EFM8 Busy Bee

EFM8BB3 Errata

This document contains information on the EFM8BB3 errata. The latest available revision of this device is revision D.

3.3 PKG_E101 – Top Marking Right Justified

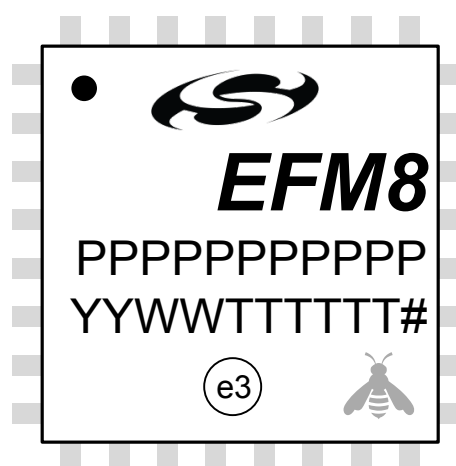
The Package Marking diagrams indicate that the package marking is left justified. However, QFP32 devices with the 1531 date code have package markings that are right justified.

Assembly houses expecting left-justified package marking may see some parts with right-justified package marking.

This issue only affects revision A QFP32 devices with a date code of 1531. All other devices should match the Package Marking diagrams in the device data sheet.
